REQUEST for PROJECT CHANGE ('RPC')
WOOLOOWIN WORKSITE MODIFICATION

**Report on Principal Construction and Community aspects associated with the
RPC**

**Queensland Department of Infrastructure and Planning
(as agent for the Coordinator-General)**

G M Peck & Associates Pty Ltd
Author: G M Peck

Figure 3.1

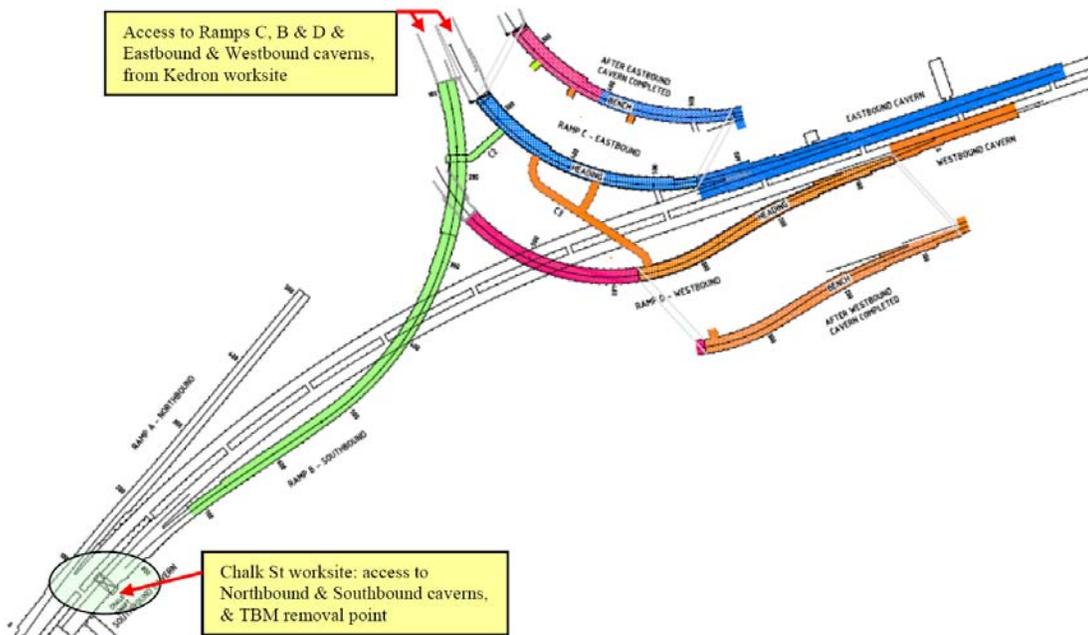
The diagram following (Figure 3.1) has been reproduced from the RPC Appendix 1-A with the addition of some explanatory notes to identify the terms used in the RPC and subsequent sections of this review.

The indicated access for ramps B, C and D plus the Eastbound and Westbound caverns is that intended before the identification of the geotechnical conditions now known to exist.

The expected geological conditions would have allowed completion of the ramps and caverns about three months in advance of the TBM arrival, thus left a reasonable margin for variances in the estimated progress and overcoming occasional localised unexpected ground conditions. The bench sections of the ramps were largely to be completed after the critical cavern sections were done – this strategy is identified on Figure 3.1 above.

Figure 3.2.a: GP08 - Roadheader resources & Workfront locations

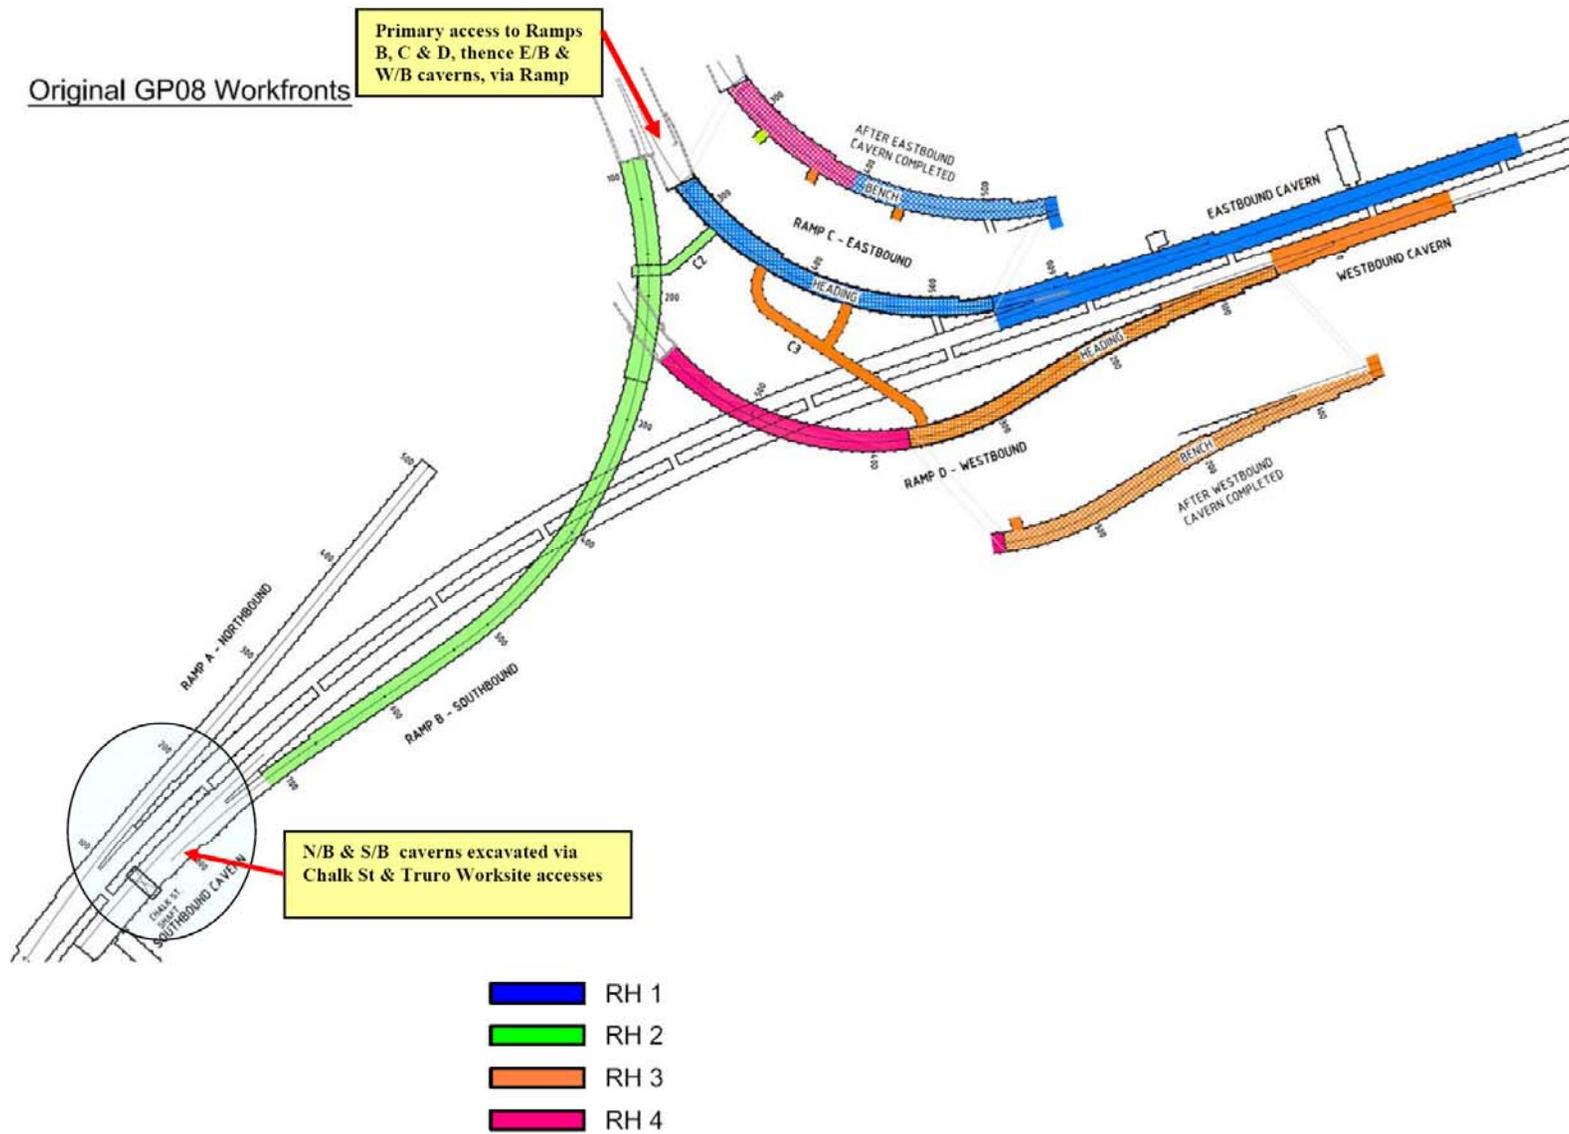
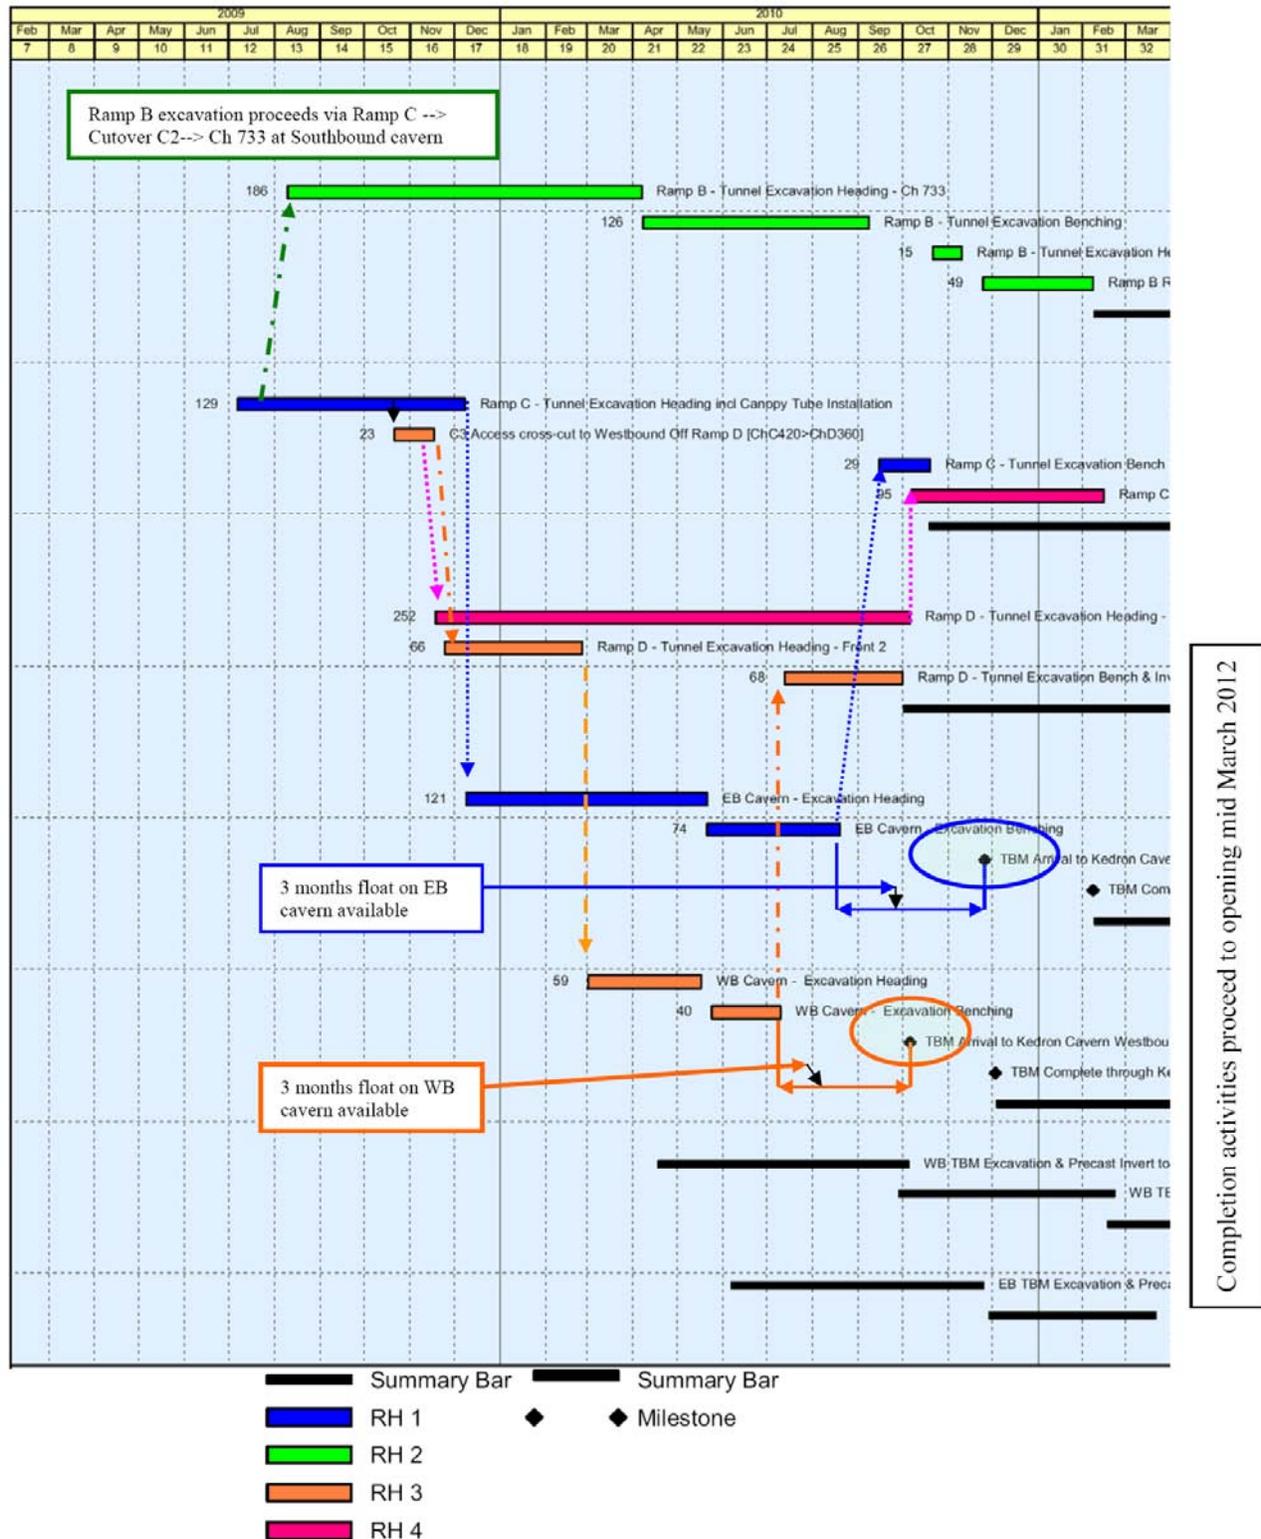
The RPC does not specifically address the overall project delay that would result if the original construction sequencing and Roadheader resources were to continue to apply. However, it is obvious that the delay to completion of the Westbound (W/B) and Eastbound (E/B) caverns would be not less than the 12 months indicated slip in the cavern completion dates indicated in Table 3-4 for the comparison between the program dates given for “Original GP08 ...Work fronts” [*W/B cavern. 10/07/2010; E/B cavern 20/8/2010*] and “GP08 Alternative 1” [*W/B cavern. 22/06/2011; E/B cavern 18/8/2011*]. It can be seen from the version of GP08 Original program reproduced as Figure 3.2.b hereafter that the cavern completion dates had about 3 months float relative to the ‘Must be completed by’ arrival date of the TBMs at each of the W/B and E/B caverns. Since the ‘GP08 Alternative 1’ program already includes for the addition of 1 extra Roadheader spread (making 5 compared to the original 4), it is readily apparent that absent any mitigation steps, the impact of the revised geological conditions would be at least (12-3 = 9) months delay to the project opening.

The program logic depicted in the Appendix A-1 “Original GP08 Work-fronts” of the RPC has been summarised in Figures 3.2.a & 3.2 .b following.

Figure 3.3.a Underground sequencing logic to achieve six (6) Roadheader workfronts from original Kedron & Chalk St access points

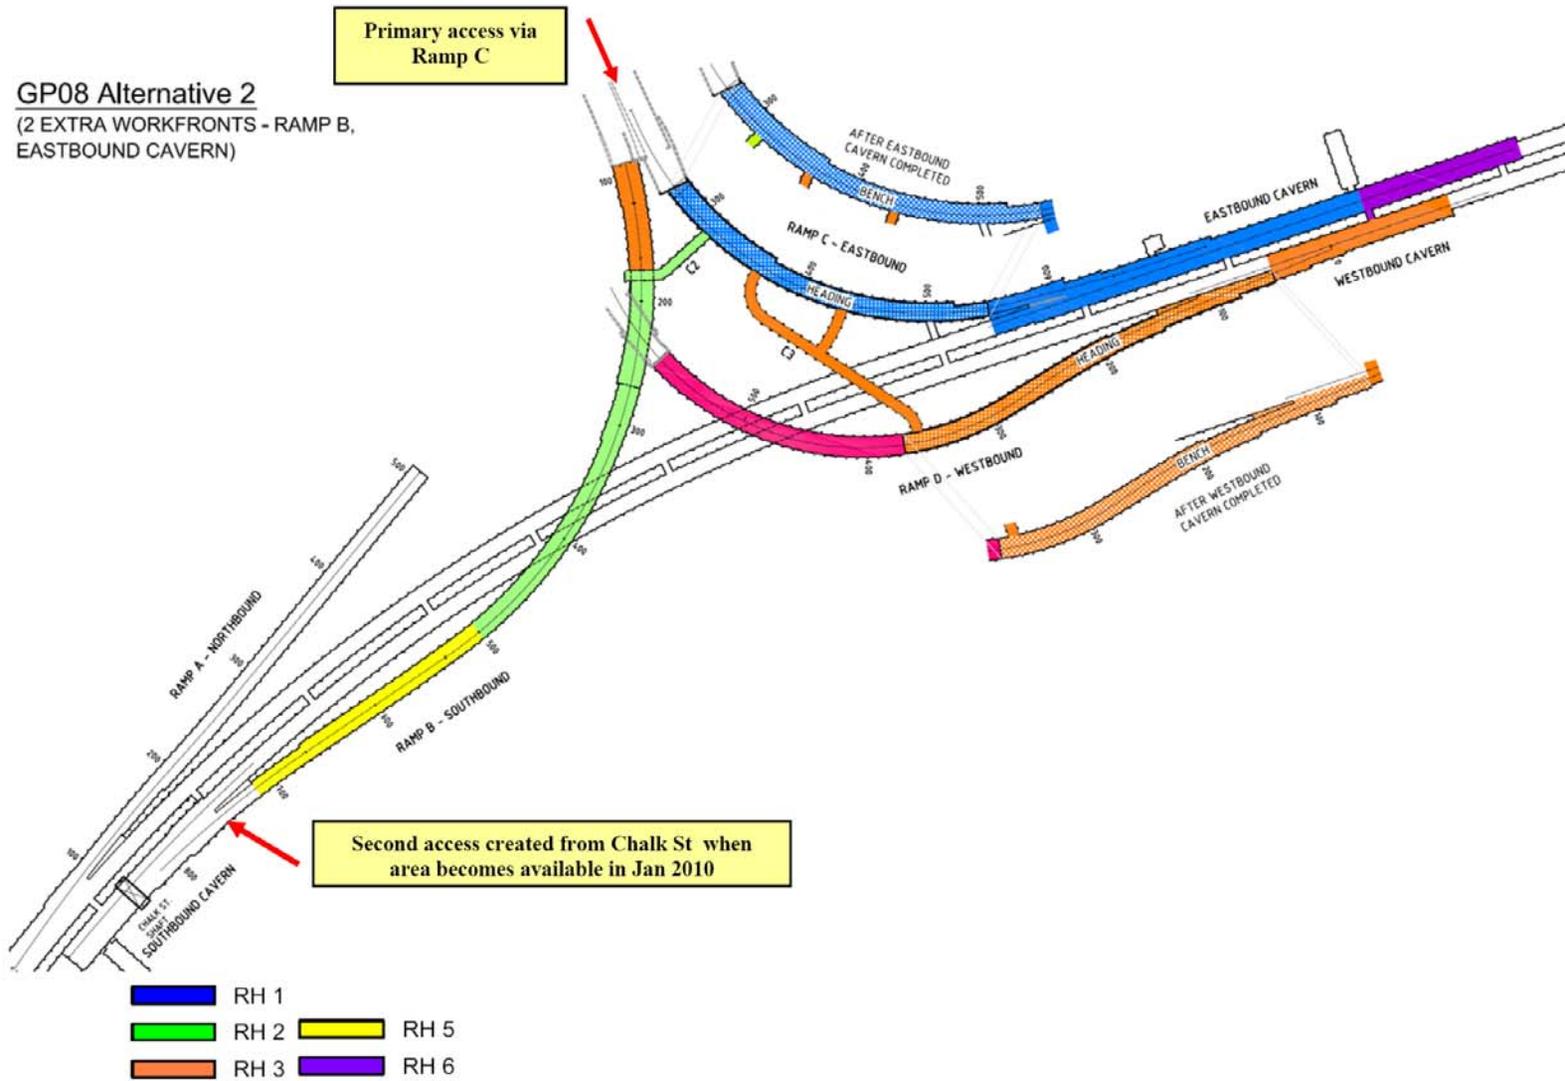
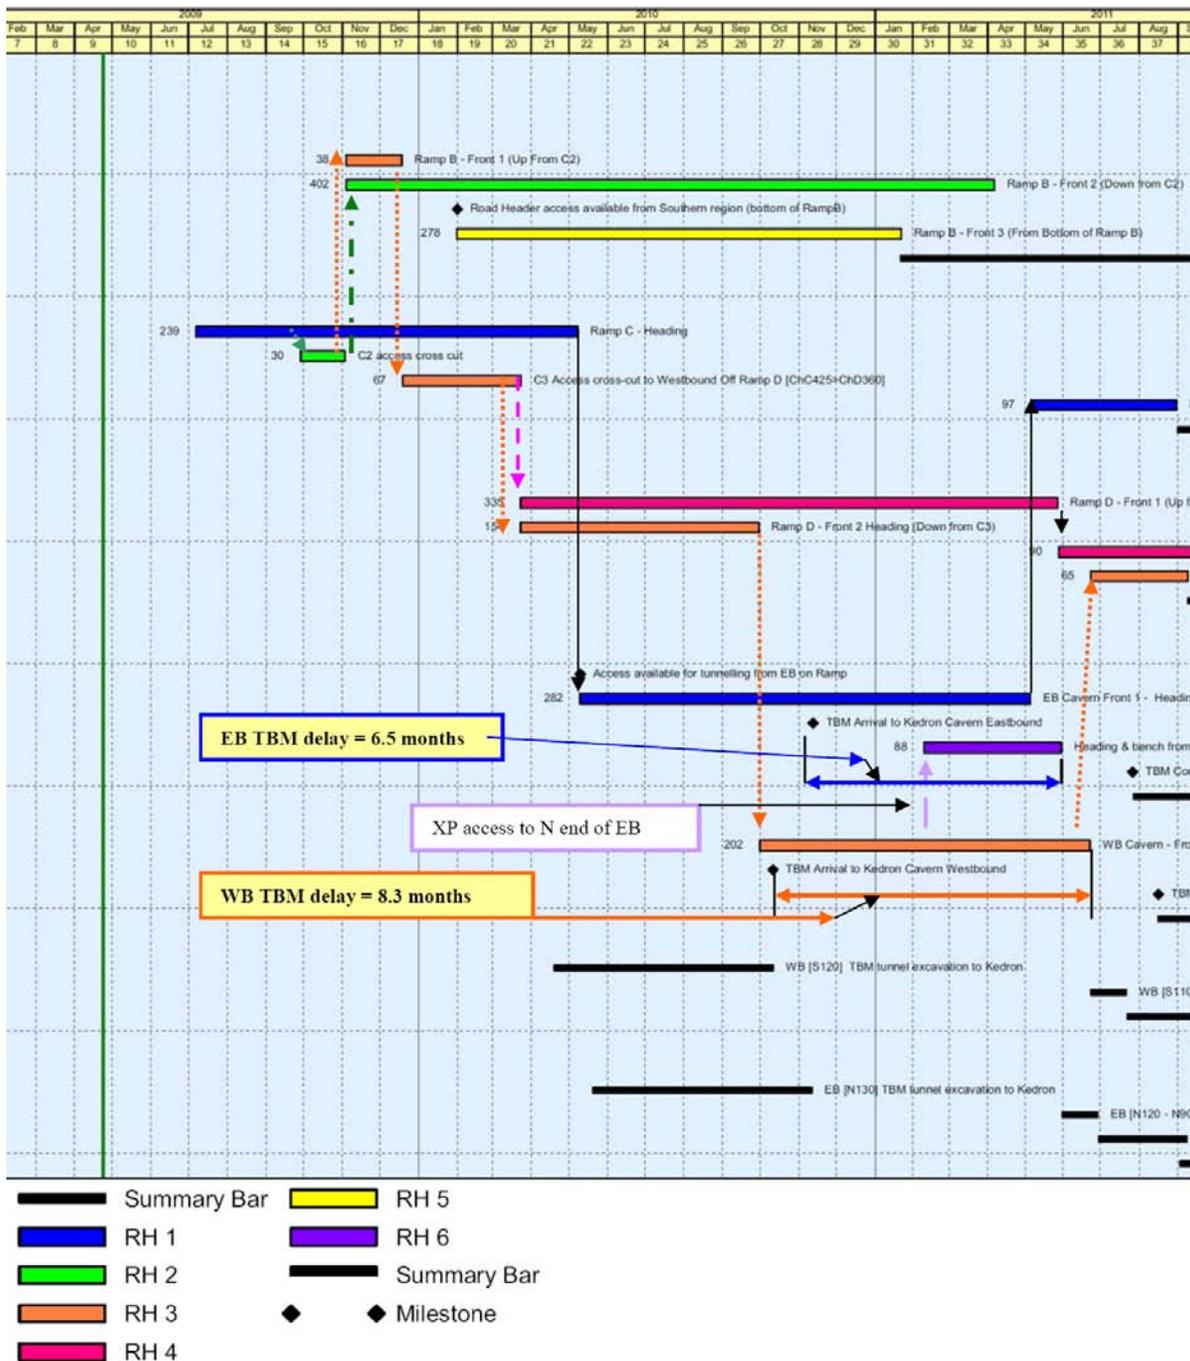
The work sequence logic and program outcomes resulting from option iii are reproduced in figures 3.3.a and 3.3.b following. This still results in an overall projected delay of the order of seven to eight months. In the reviewer's opinion, **option iii** represents the maximum benefit likely to be gained without the addition of a completely new access point to the Eastbound and Westbound caverns. In practical terms, any such new worksite will involve a major roadheader operation based upon development of a shaft to access the appropriate cavern area from the shaft well in advance of the time possible from the original ramp accesses.

Completion activities follow TBM completion. Opening delayed until end Nov 2012, total delay approximately 7.5 months
